North Wambo Underground Coal Mine MOD 14 (LW 10a) – additional information

**NSW Office of Water's detailed technical advice:
North Wambo Coal Mine MOD 14 – additional information**

Figure 2: Alluvial observation bore in midpoint LW10A

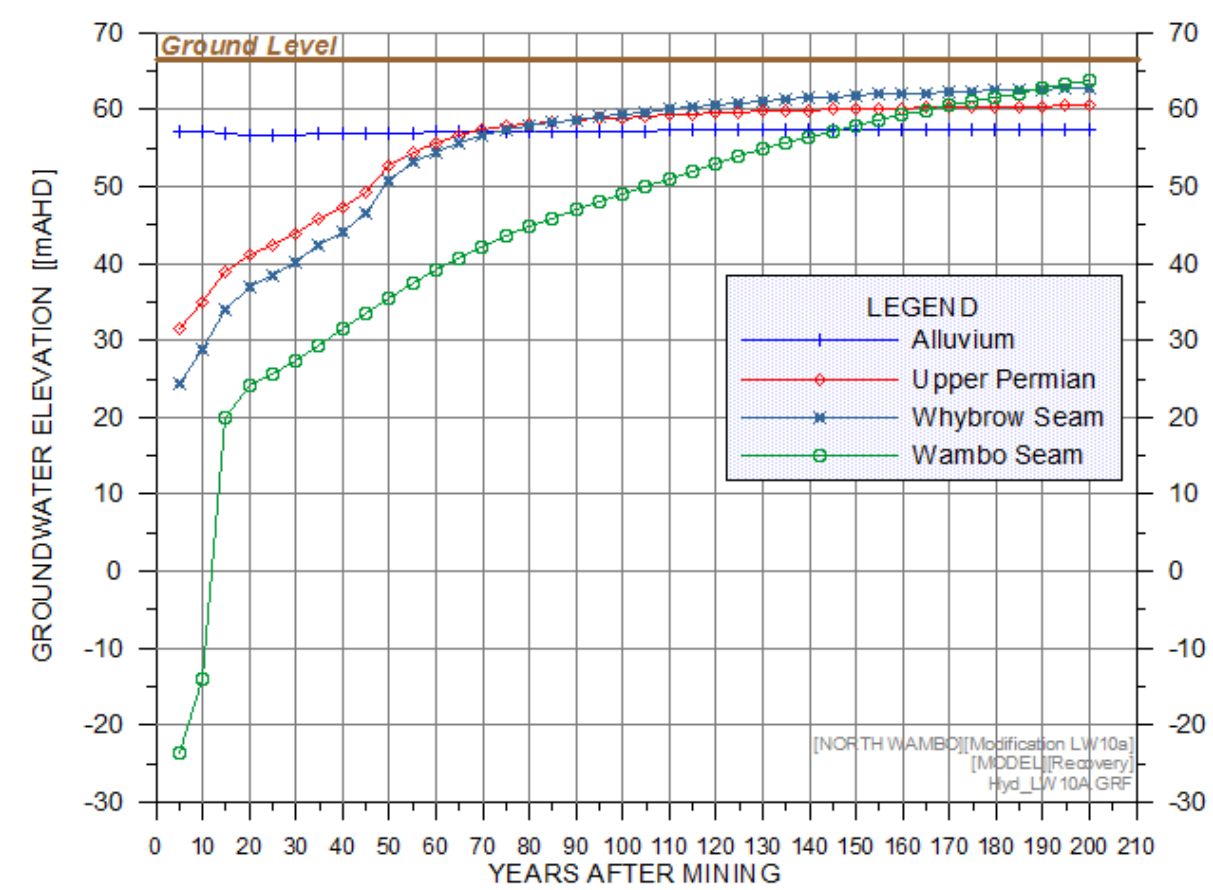
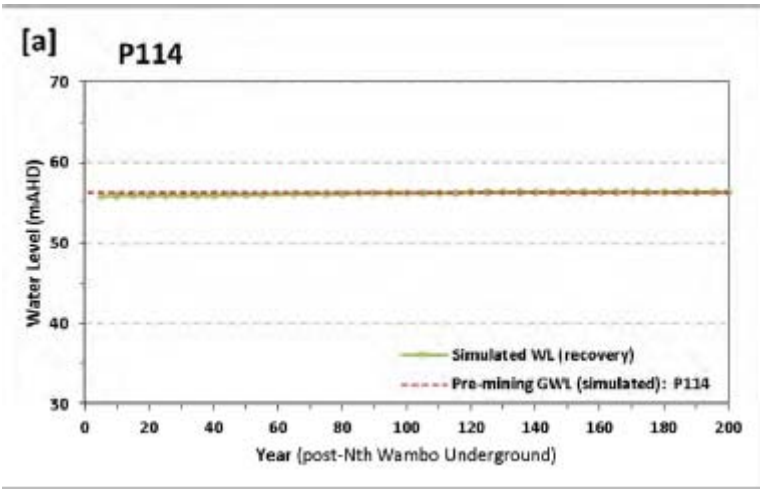
WCPL present in Figure 1 below the hydrograph modelling results for a synthetic bore located in the midpoint of LW10A. Figure 1 presents a 3m (upflow) head difference is generated between Permian and alluvium. Whilst the proponent does now acknowledge the upflow, it remains that the groundwater model doesn't incorporate the substantial land subsidence that will occur in this location. Observation point P114 is an actual alluvial bore located in mid-point of LW10A and had pre-mining levels around 58m AHD (Figure 2), i.e. identical to that of the synthetic bore. Previous Office of Water commentary has demonstrated the alluvium in LW10A will be subsided by as much as 9.5m in this area.

The proponent continues to side step subsidence as an issue for groundwater flux. Given the groundwater model can not assess what can logically be concluded, concerns with the long term impacts of the proposal remain. By ignoring this issue the proponent has not demonstrated with sufficient rigour the impacts of the proposal. It is clear that the upflow from the Permian to the alluvium is predicted which results in the mixing of aquifers of different water quality. Under increased Kz being generated in the Permian combined with alluvial land subsidence, these impacts will be greater than that put forward in the supplementary report. Further, this outcome contradicts that presented in the EA.
